Errata: CS43L43 Rev. D

CS43L43 Low Voltage, Stereo DAC with Headphone Amp

Figure 1. Pop Guard Fix

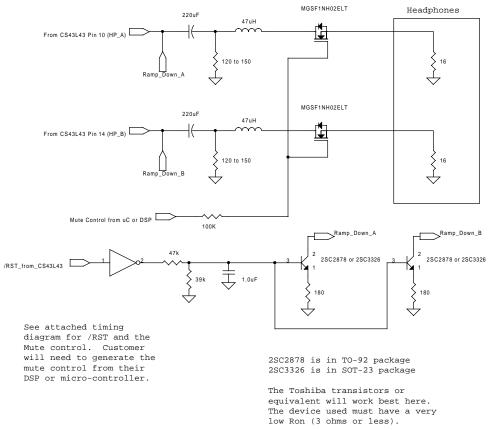
- The PopGuard[©] Transient Control does not function properly and will produce audible artifacts on the headphone outputs during power-up. A hardware fix is available for this issue and is shown in Figures 1 and 2.

- The PopGuard[©] Transient Control power-down ramp requires 5 seconds to prevent audible artifacts on the headphone outputs at the next power-up. A hardware fix is available for this issue, see Figures 1 and 2 for details. This fix will reduce the ramp down time to approximately 300 milliseconds.
